**Royal Borough of Kensington and
Chelsea Basements Policy**

Hydrologic Review of Basements,
Publication Planning Policy

Revised Issue | 27 August 2013

Job number 230276-00

Drawing Title
EXAMPLE STORMWATER MANAGEMENT STRATEGY

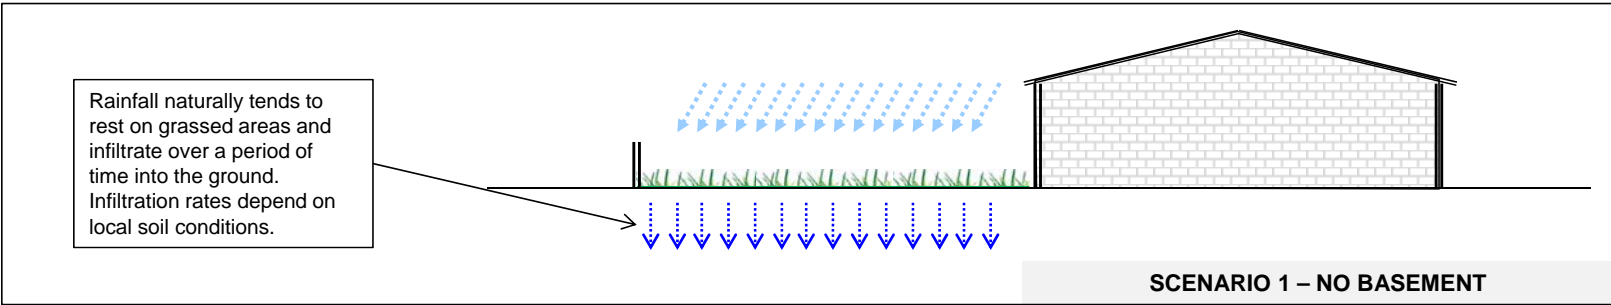
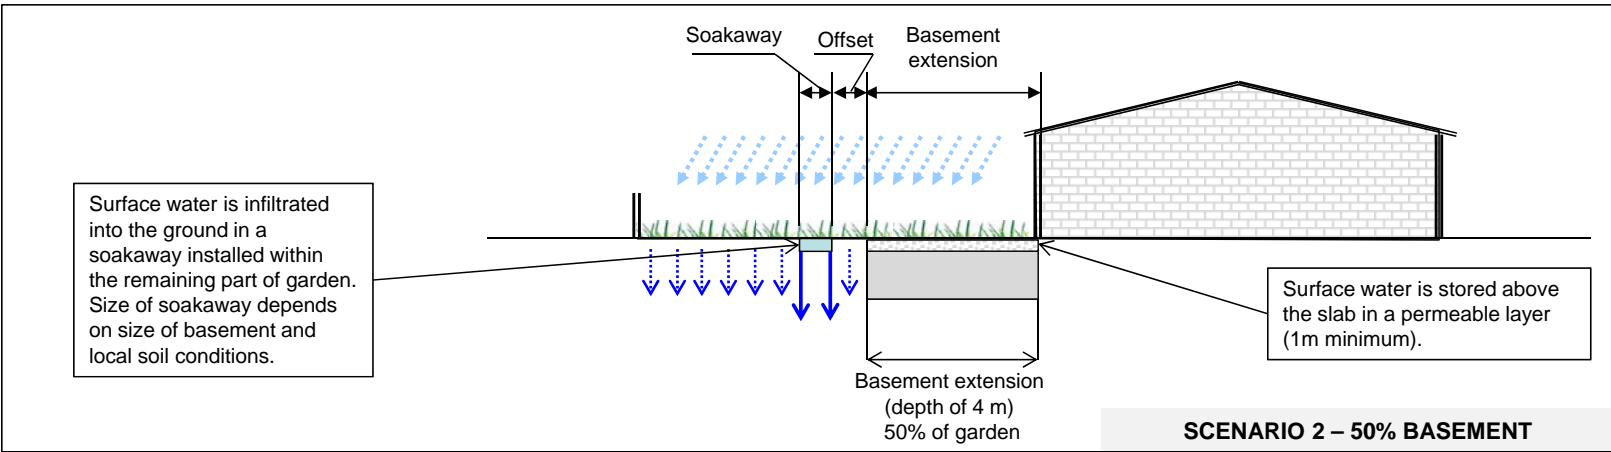
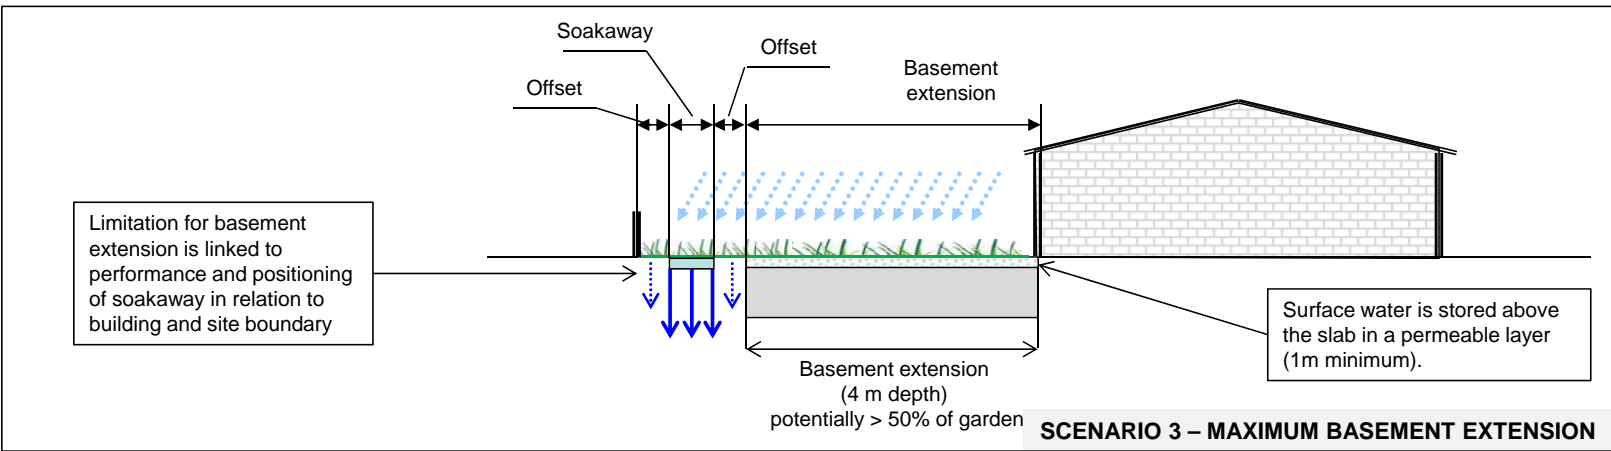
To demonstrate this, we have illustrated three scenarios on Figure 4. The scenarios are as follows:

Scenario 1 – No basement – this is a typical small site as defined above in Section 3, the garden allows natural infiltration of surface water into the ground.

Scenario 2 – 50% rule – a typical small site where Policy CL7 is implemented. A permeable soil storage zone is provided above the basement slab to provide attenuation and a soakaway is provided in the garden area connected to the storage zone to enable a discharge to ground.

Scenario 3 – Maximum Basement Extents – This scenario illustrates a basement extension where the constraints imposed by storm drainage are at the limits of design. Again attenuation is provided in a permeable soil zone above the basement slab and a soakaway is provided in the garden space. However, there is only enough space to position a soakaway within the setback required by building control for properties and the site boundary.

The above scenarios help to illustrate the following:

- Engineering methods are available which can be used to maintain or improve storm water storage and infiltration capacity within the site curtilage.
- A simple limitation of 50% may preclude innovative methods which improve overall drainage conditions within the Borough.
- There is a limit to the amount of garden which can be developed into a basement. To establish this limit, site specific assessment will be needed, a general rule cannot be applied.
